**NUCLEAR**  
**PACKAGING**  
A Pacific Nuclear Company

File: OH-142

Enclosed please find eight copies of the revised pages to convert Revision 11 of the OH-142 Safety Analysis Report to Revision 12 of that report.

## Insert/Delete Instructions for Rev. 12, OH-142 SAR

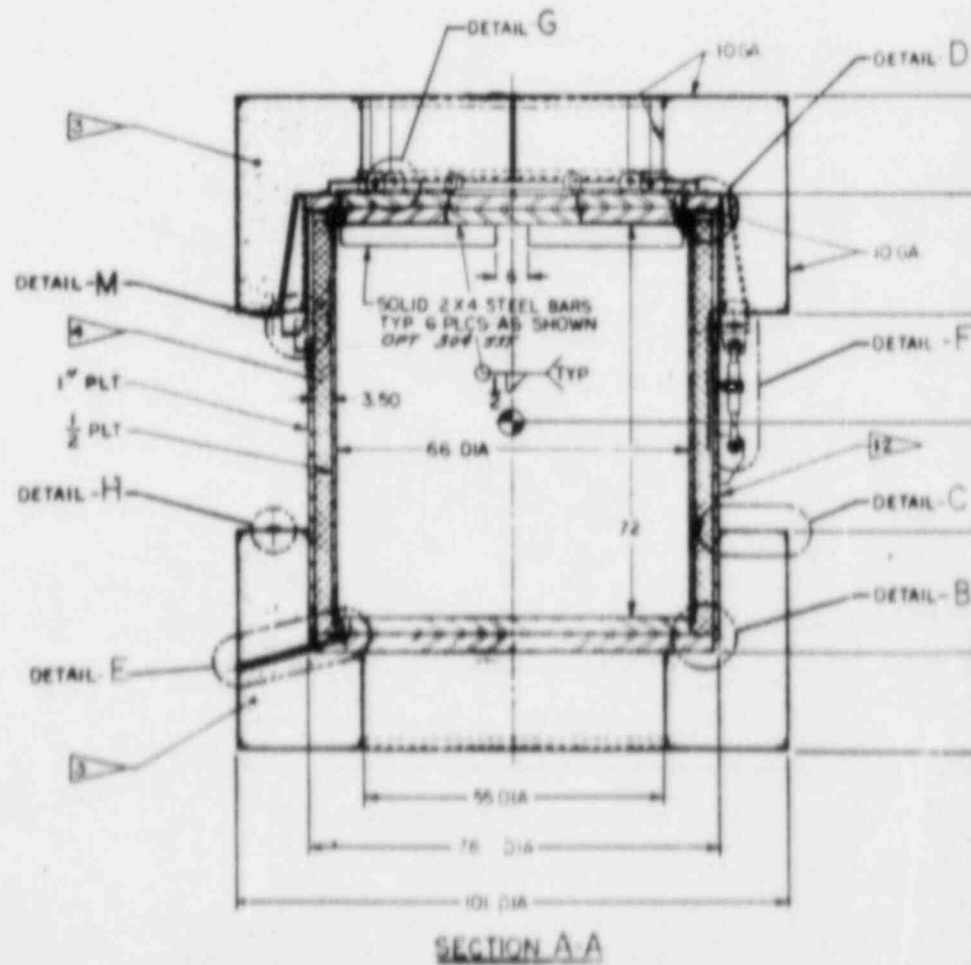
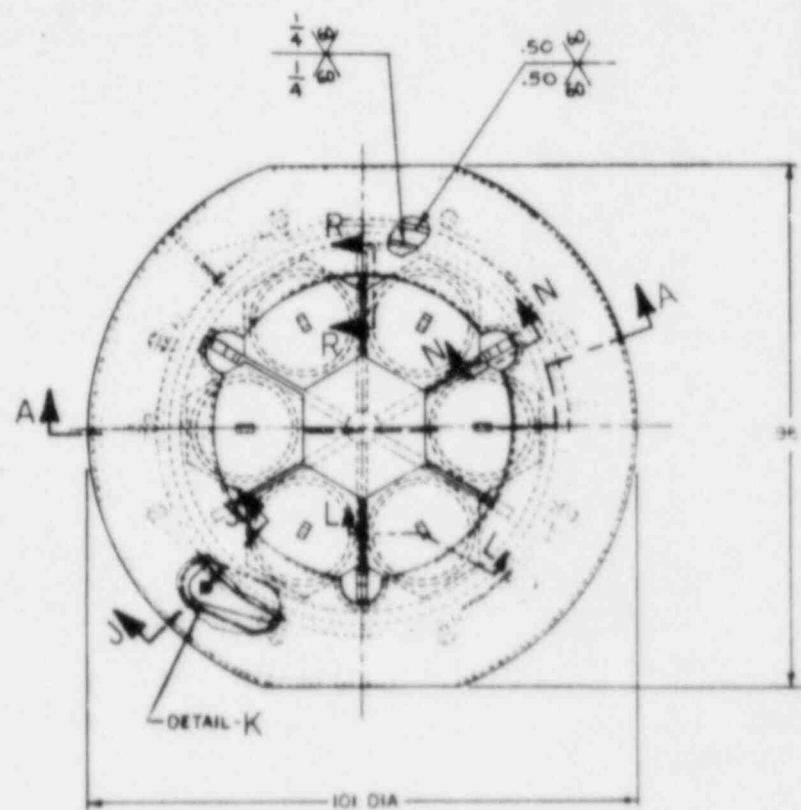
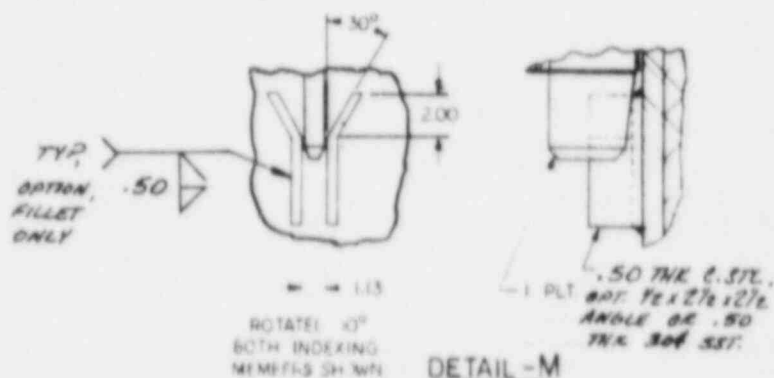
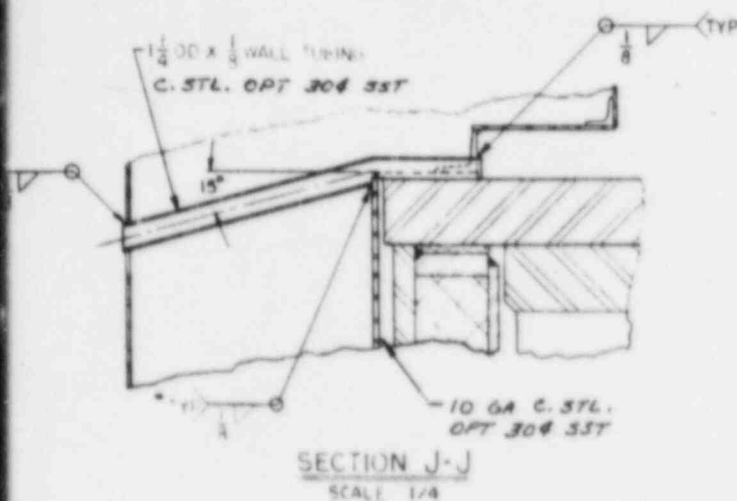
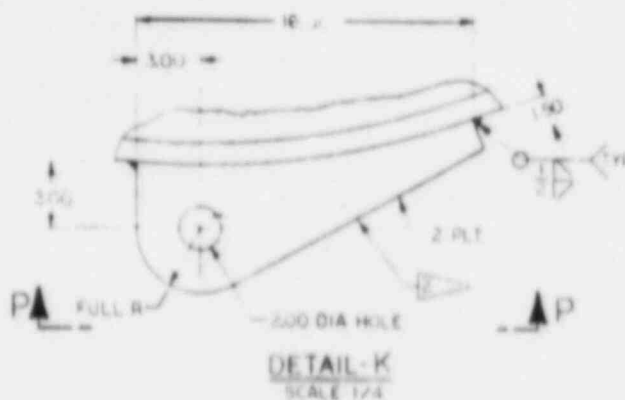
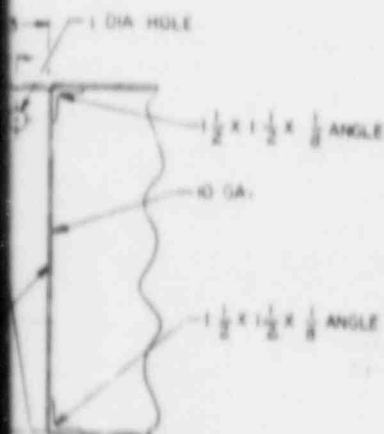
In addition to the analysis previously contained in the SAR, a thread engagement calculation was included in this submittal. To assure that the thread engagement required to fully develop the strength of the bolt is present on packages in service, the required thread engagement has been added to Drawing AL-20-202, as well as a note specifying that the revised foam properties allowed in NPI.F6 foam are allowed only for the 16 inch central secondary lid option.

2. MATERIAL : ASTM-A514 OR A517
3. FOAM: 1,000 PSI CRUSH STRENGTH RIGID POLYURETHANE, PER NUPAC FOAM SPECIFICATION NPI-F6, REVISED FOAM PROPERTIES ALLOWED FOR 16 INCH DIAMETER CENTRAL LID OPTION.

Dwg. AL-20-202 Rev. K
